# UNITED STATES PATENT AND TRADEMARK OFFICE

APPLICATION NO.	FILING DATE	FIRST NAMED INVENTOR	ATTORNEY DOCKET NO.	CONFIRMATION NO.
10/686,439	10/14/2003	Hirofumi Konishi	47434-00053	6874

<b>Office Action Summary</b>	<b>Application No.</b> 10/686,439	<b>Applicant(s)</b> KONISHI, HIROFUMI	
	<b>Examiner</b> John A. Jeffery	<b>Art Unit</b> 3742

## **DETAILED ACTION**

Regarding claims 26 and 27, note "outer pipe" 32a and coaxial "inner pipe" with flange illustrated below in a reproduction of Fig. 6 of EP536472:

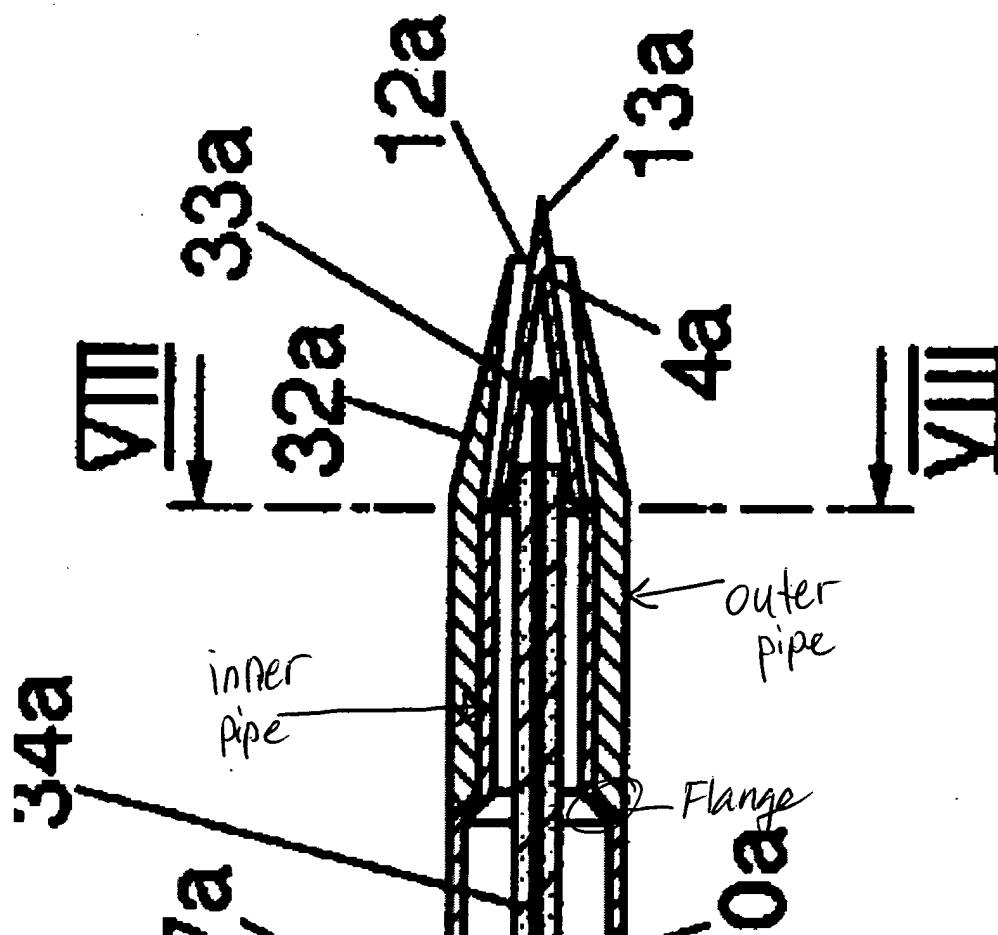
In view of EP536472, it would have been obvious to one of ordinary skill in the art to provide an outer and inner pipe structure for the exhaust pipe of the previously described apparatus to create a narrow circumferential airflow path adjacent the soldering tip.
